## XTLC Control Panel

December 2013

### Hardware Update

Beginning December 30, 2013, all XTLC Control Panels are being manufactured with updated Level F hardware.

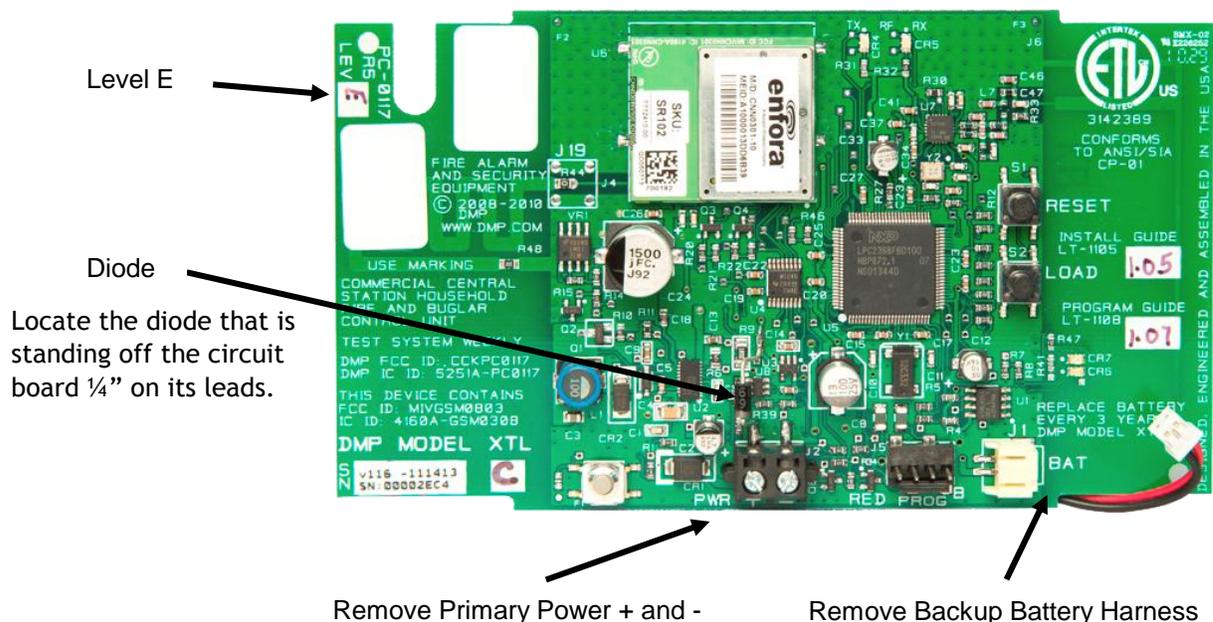
Level F hardware removes a diode from the XTLC circuit board power supply that was used to operate an optional 738Z Z-Wave Interface Module during periods of primary power loss. With this diode removed, the XTLC will detect and report the loss of primary power. In addition, a connected 738Z will only operate when primary power is present.

## Remove Diode

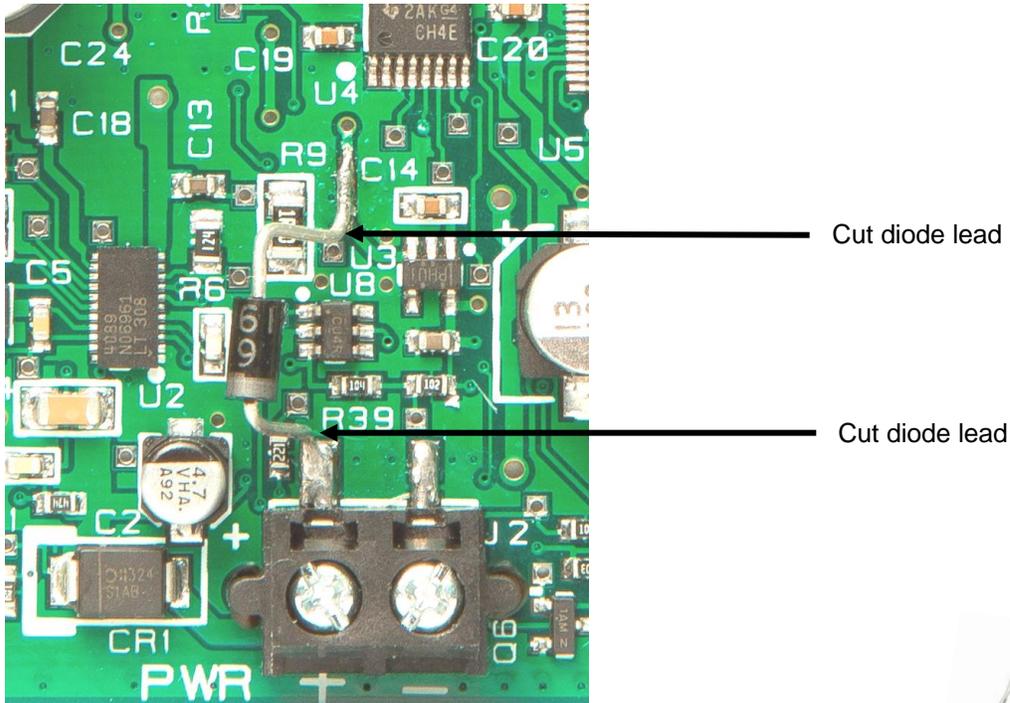
XTLC Level E hardware is identified by the 'E' marking located on the top left corner of the circuit board as shown below.

Disconnect the primary power input wires connected at PWR + and -. Unplug the backup battery harness connected at BAT on the lower right side of the circuit board.

Using small sharp wire cutters, gently remove the diode by cutting the leads just above the circuit board as indicated below.

Discard the diode, reassemble and test the XTLC.

With this diode removed, the XTLC will detect and report the loss of primary power and a connected 738Z only operates when primary power is present.
